5.2 Advisory Agency Responses

**NEW ACLAND COAL MINE
STAGE 3 PROJECT**

**Figure 5.2-A - Clearance Map
for Defence (June 2014)**

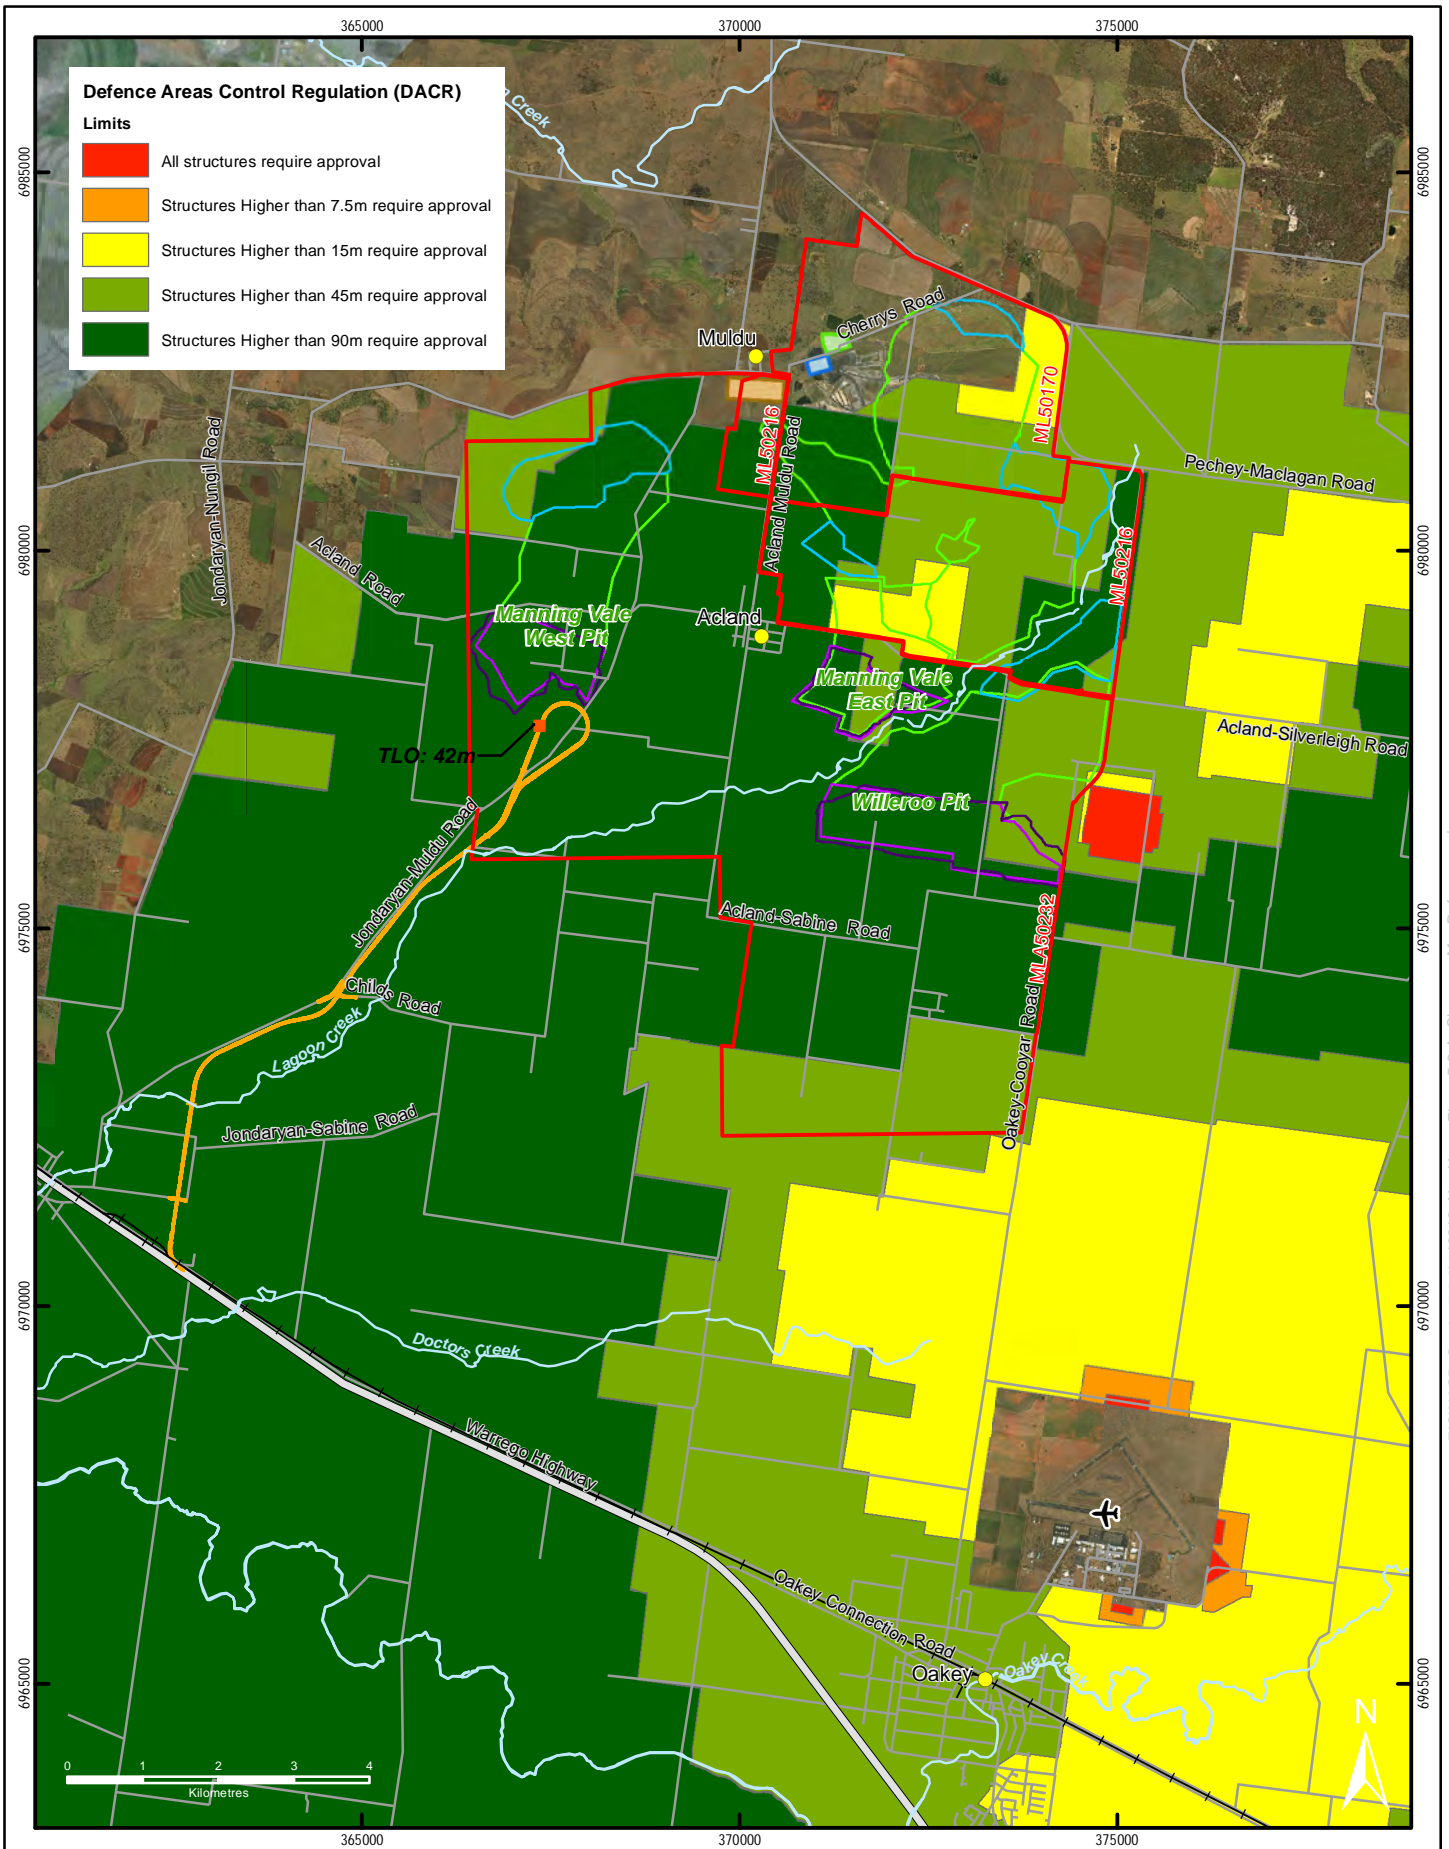
NAC takes note of the restrictions placed on the height of objects within a radius of approximately 15 km of Army Aviation Centre (AAC) Oakey as stipulated in the Defence (Area Control) Regulations. NAC will seek assessment and approval for any tall structures that is above 30 m above ground level within 30 km of the AAC Oakey, and any tall structures that is above 45 m above ground level elsewhere as depicted in **Figure 5.2-A** of the AEIS.

Figure 5.2-B: Existing intersection layout – Jondaryan Sabine Road/ Warrego Highway

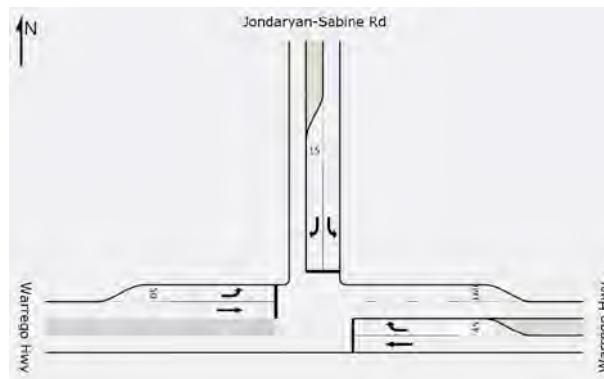
The existing layout of Jondaryan Sabine Road / Warrego Highway intersection and the length of the turn lanes are illustrated within **Figure 5.2-B**.

The results of the SIDRA testing for the intersection capacity impacts show that the Warrego Highway/Jondaryan-Sabine Road intersection would perform within the acceptable range of DoS, delays and queues for the peak construction (2016) phase, the operation (2017) phase and the ten year horizon (2027) phase.

Figure 5.2-D: Existing intersection layout – Peachey Maclagan Road/ Northern MIA Access Road

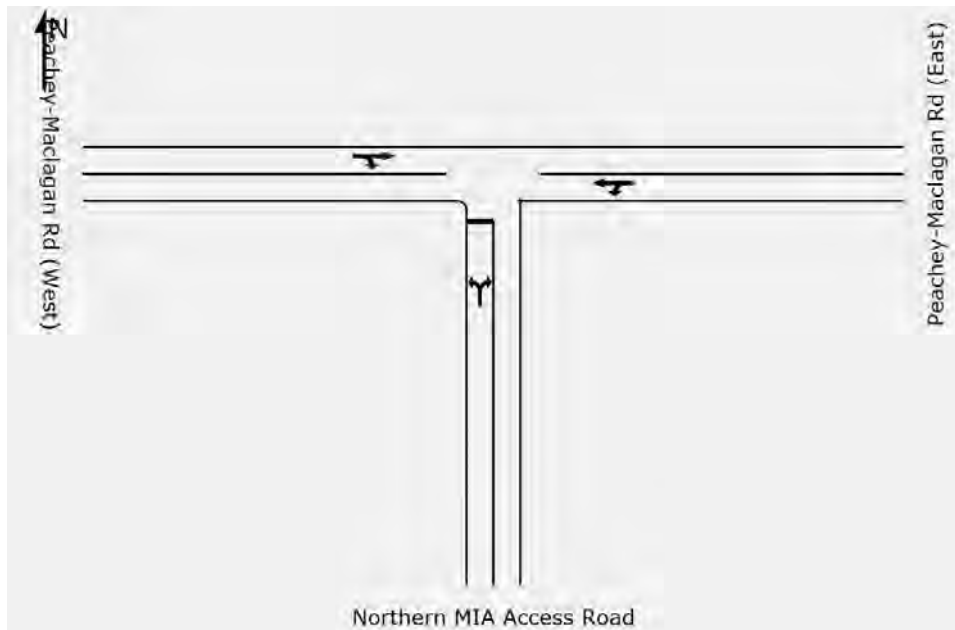
The existing layout of Peachey-Maclagan Road /Northern MIA Access Road intersection and the length of the turn lanes is illustrated within **Figure 5.2-D**. The intersection currently operates under a give-way control. Cherrys Road is a former public road within ML 50170 that is closed for public use. The former Cherrys Road alignment is used for internal access purposes. A new Northern Access road will be constructed for light vehicle access from Oakey-Cooyar Road. Therefore, all traffic that were traversing Cherrys Road will now use Northern MIA Access Road.

The results of the SIDRA testing for the intersection capacity impacts show that the Peachey-Maclagan Road /Northern MIA Access Road intersection would perform within the acceptable range of DoS, delays and queues for the peak construction (2016) phase, the operation (2017) phase and the ten year horizon (2027) phase.

Figure 5.2-E: Existing intersection Layout –Acland Sabine Road/ Oakey –Cooyar Road

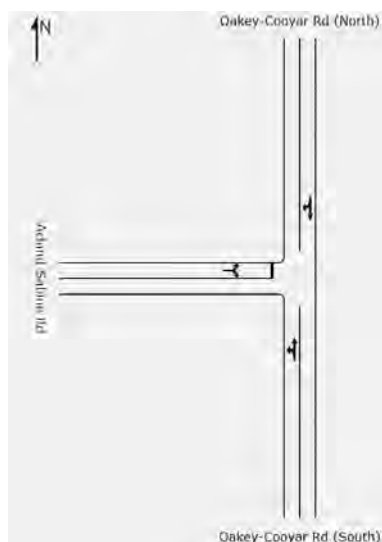
The existing layout of Acland Sabine Road/Oakey –Cooyar Road intersection and the length of the turn lanes is illustrated within **Figure 5.2-E**. The intersection currently operates under a give-way control.

The results of the SIDRA testing for the intersection capacity impacts show that the Acland Sabine Road/ Oakey – Cooyar Road intersection would perform within the acceptable range of DoS, delays and queues for the peak construction (2016) phase, the operation (2017) phase and the ten year horizon (2027) phase.

Figure 5.2-F: Existing intersection Layout – West Duke Street/ Warrego Highway

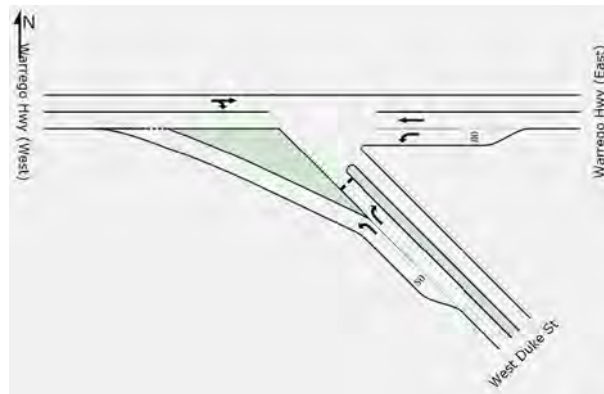
The existing layout of West Duke Street and Warrego Highway intersection and the length of the turn lanes is illustrated within **Figure 5.2-F**. The intersection currently operates under a give-way control.

The results of the SIDRA testing for the intersection capacity impacts show that the West Duke Street/ Warrego Highway intersection would perform within the acceptable range of DoS, delays and queues for the peak construction (2016) phase, the operation (2017) phase and the ten year horizon (2027) phase.

**Figure 5.2-N - Final Landform
Depth PMF**

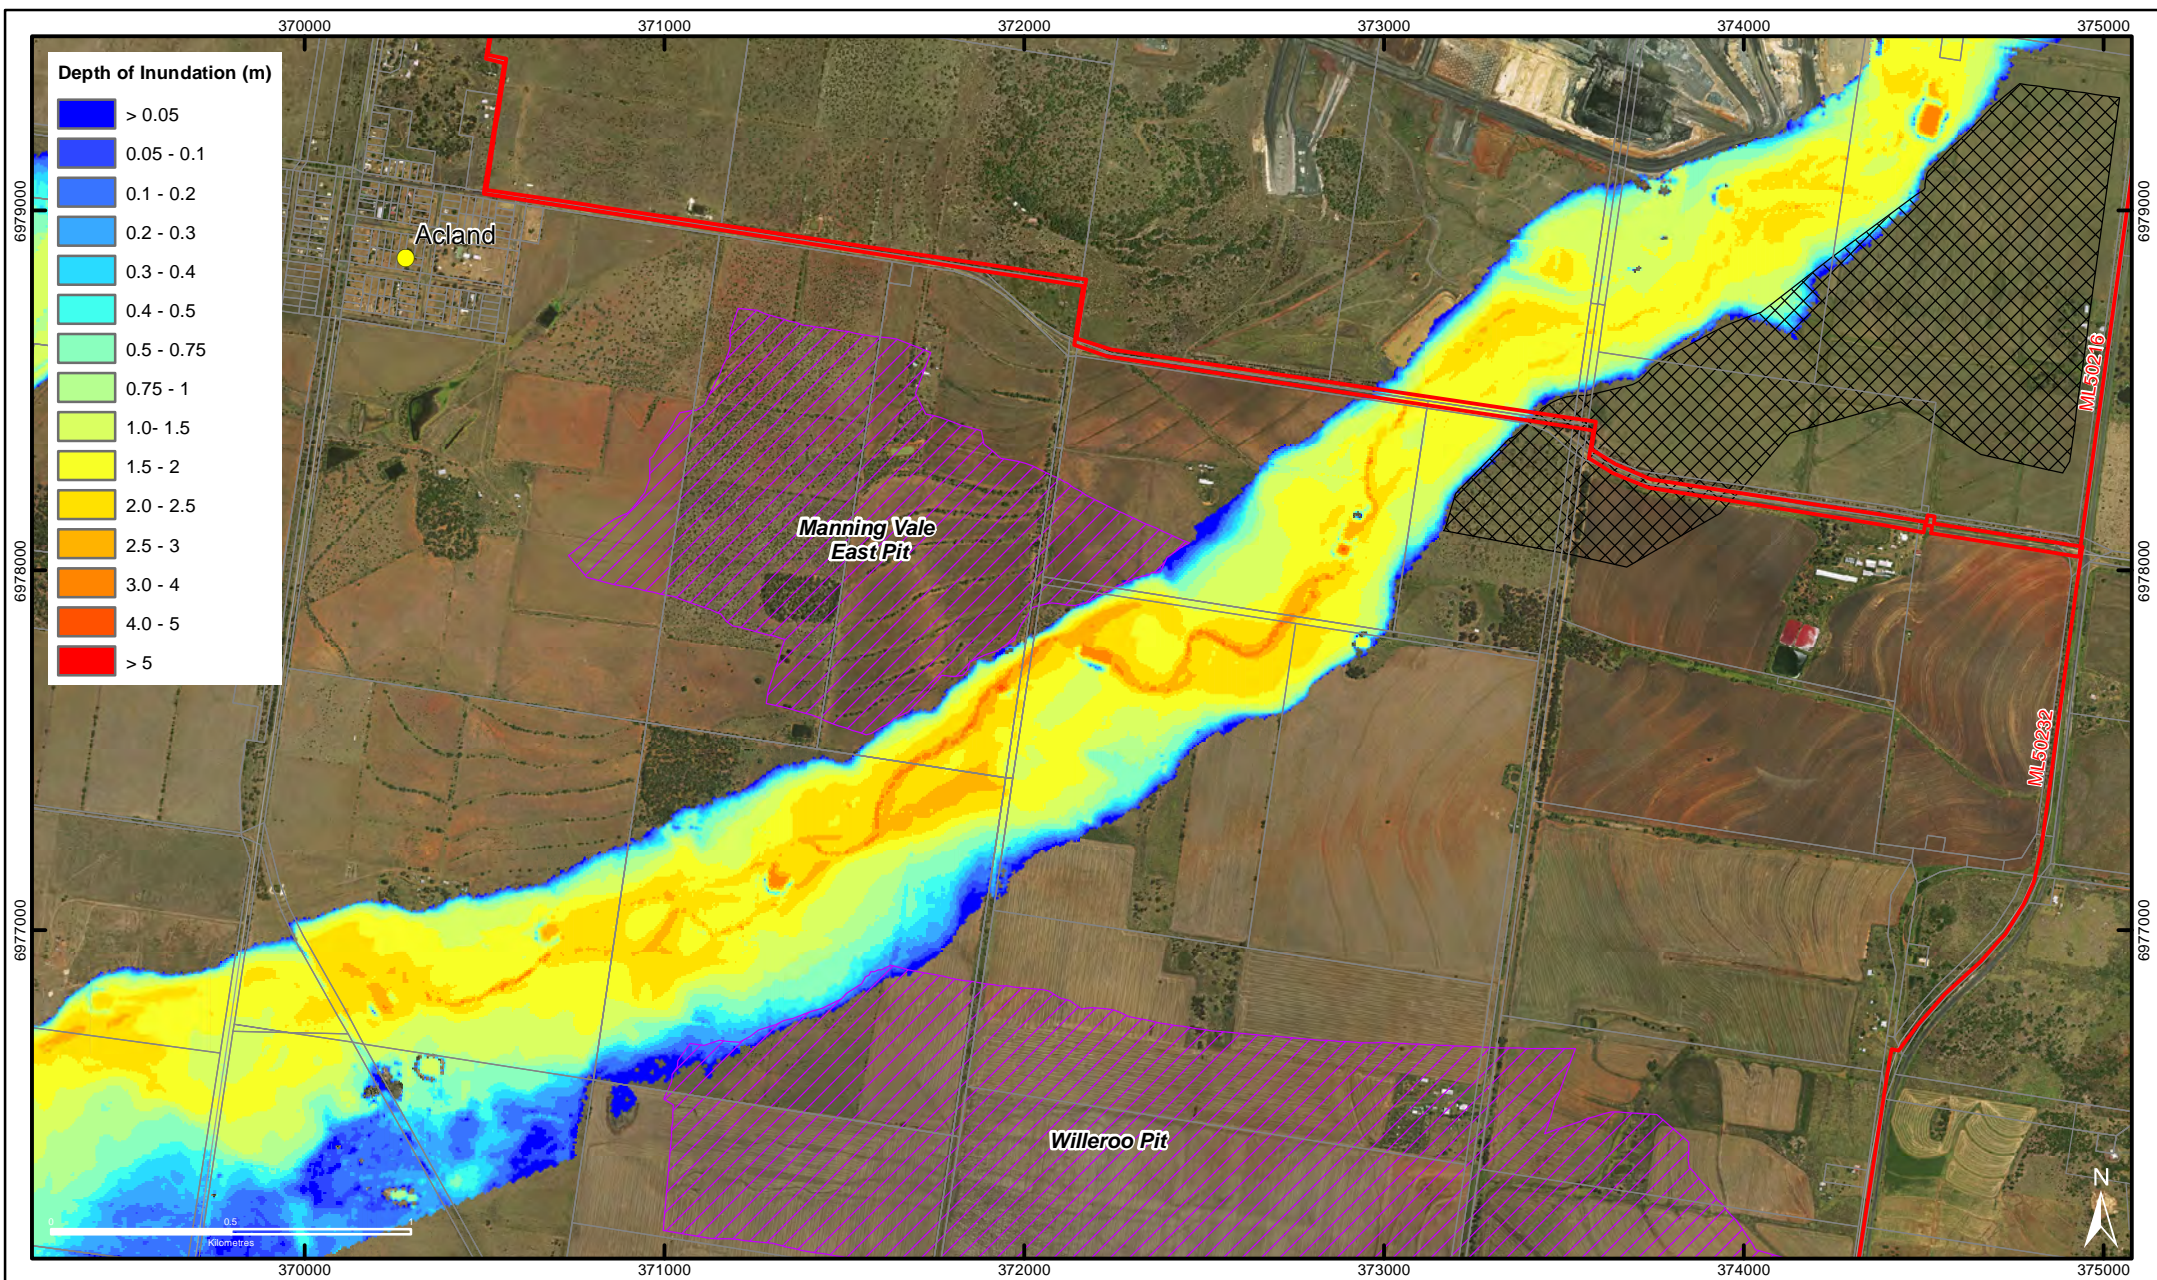
A potential impact of the revised Project is the impact of the final landform on flood behaviour. To mitigate this impact NAC have committed to the design and construction of a final depressed landform that is largely located outside the extent of the Probable Maximum Flood (PMF). This commitment was made during the EIS process based on the results of the flood impact assessment. This commitment was made to be implemented as part of the detailed design of the depressed landform. This design is currently in progress.

Figure 5.2-N illustrates the approximate extent of the revised final landform presented relative to the existing PMF extent. It is noted that the PMF extent presented in Figure 5.2-N is the PMF based on terrain that does not include any flood levees. That is the flood extent is wider than that during mining operations and therefore the final landform is further away from Lagoon Creek than the mining activities during operations.

Figure 5.2-N illustrates that the final landform will be located marginally within the PMF extent with all levees removed. However it is noted that the extent as to which the depressed landforms encroach on the PMF is very minor and in areas where the predicted depth of flooding is less than 200 mm. Therefore it is not expected that depressed landform will impact on the PMF extent or behaviour. Any water that would flow into the depressed landform would be less than 1 ha of area over a depth of less than 200 mm. This volume is negligible relative to the volume of water in a PMF event. Given this and the extremely low probability of a PMF event occurring the impact is considered to be negligible.

Figure 5.2-N also illustrates that the toe of the rehabilitated out-of-pit dump to the north east of the Willeroo pit will also extend into the final landform. To examine the impact of this on the PMF the final landform was modelled and compared to that without the dump. The impact assessment found that any impacts from the final landform would be highly localised covering an area of less than 2 ha with a maximum increase in the flood level of 30 mm. Increase in peak velocities are also highly localised and expected to remain below 1 m/s and as such scour and erosion is not expected over areas of established vegetation. Importantly, no changes to the flood or flow regime were predicted downstream of this area and there are no changes predicted in the vicinity of Jondaryan. Given the extremely low probability of the occurrence of a PMF and that the impacts are very minor and localised the impact is not considered to impact on the environment, stability of the final land form or future land uses.

Figure 5.2-O Lagoon Creek Offset Cross Section

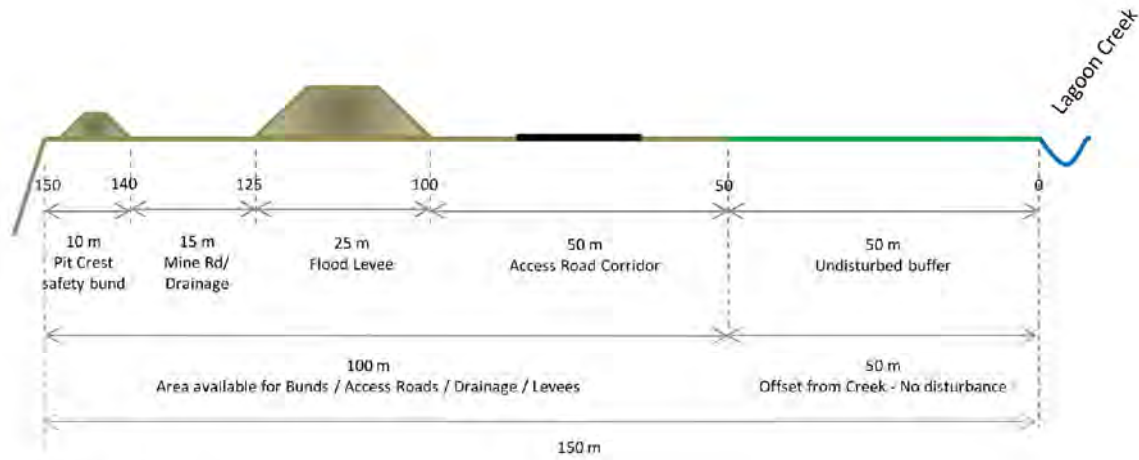
The revised Project includes an operational separation distance of approximately 150 m from the banks of Lagoon Creek to the edge of the mining pits, which includes a 50 m buffer adjacent the creek for conservation purposes. Further details on the basis for the buffer zone were provided in **Section 5.7.1** of the draft EIS.

Where Lagoon Creek is clearly braided into multiple waterways, the operational offset zone will be determined from the edge or banks of the network of channels, to avoid the boundary of the 'no disturbance' buffer being located within the creek itself. Where the channel is indistinct, a line of best fit for the bank habitat will be determined by environmental staff, which defines the area of aquatic ecology habitat values. This approach of commencing the buffer zone at the creek bank will avoid the boundary of the buffer zone being located within the creek itself.

The cross section in **Figure 5.2-O** depicts a 50 m offset buffer that extends from the high bank of Lagoon Creek and will not be disturbed or utilised for any mining activity. This undisturbed buffer extending from 0 m to 50 m will extend along the length of Lagoon Creek within the mine lease. The area that extends from outside the 50 m buffer to the mine pit will be disturbed and utilised for various mine infrastructure and activities as follows (note that distances are metres from the high bank of Lagoon Creek):
